Appl. No. 09/851,471  
Amdt. Dated August 21, 2006  
Reply to Office Action of March 7, 2006

**Amendments to the Drawings:**

Remarks:

FIG. 1  
PRIOR ART

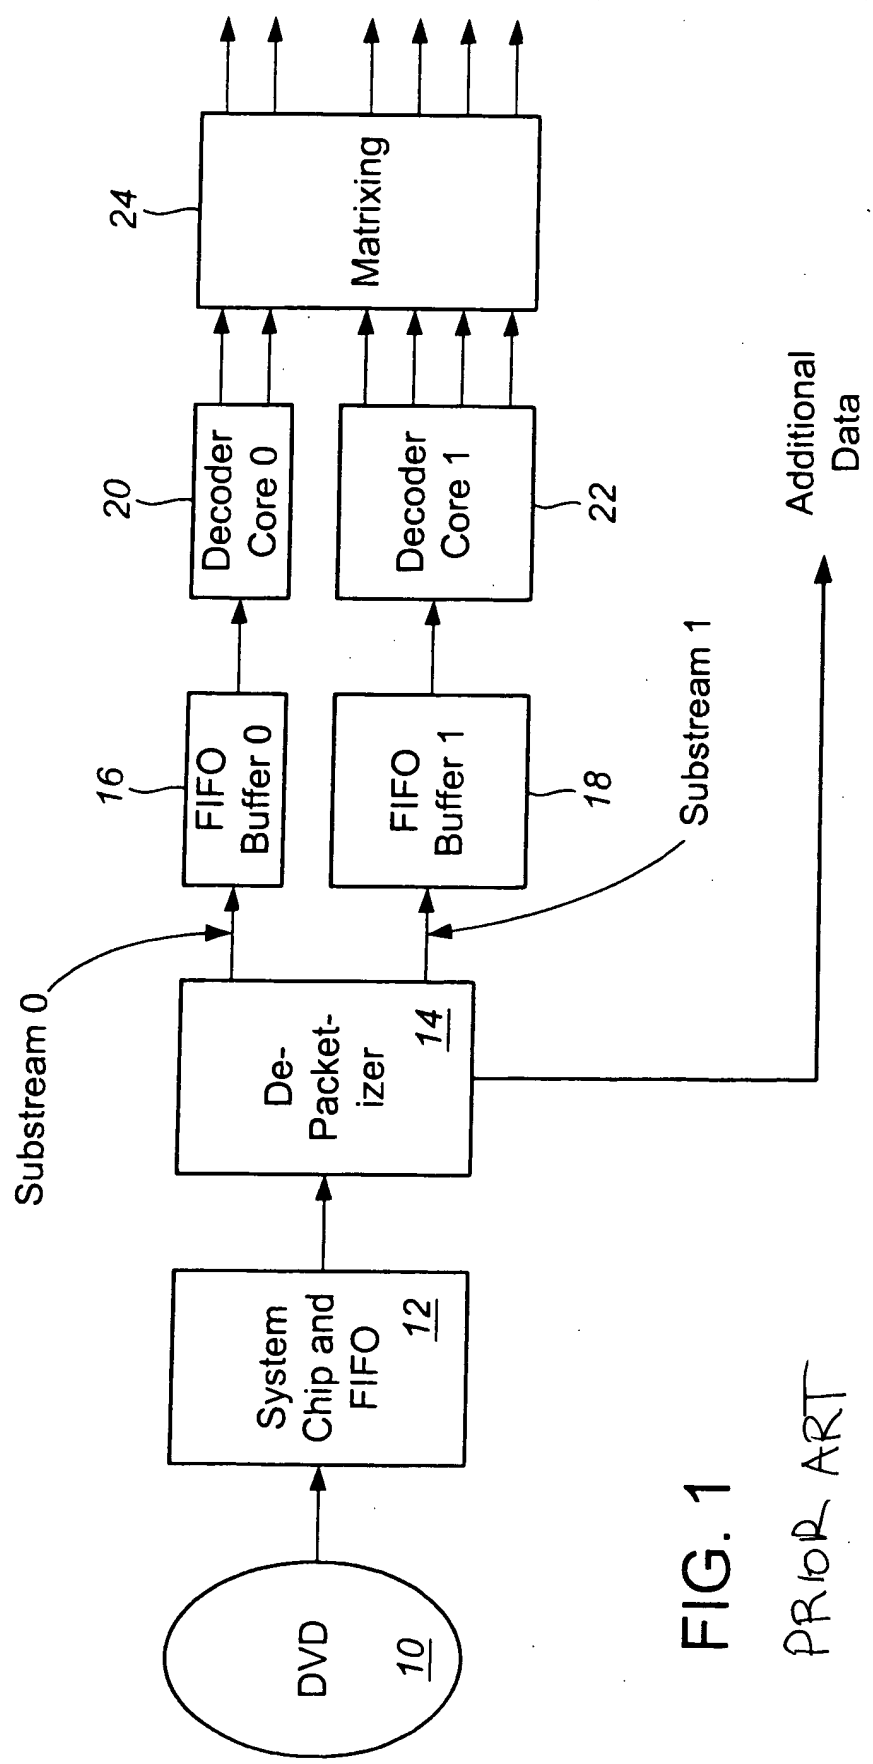
The attached sheets of drawings includes changes to FIGS. 1-3. These sheets replace the original sheets including FIGS. 1-3. The legend "Prior Art" has been added to FIGS. 1-3.
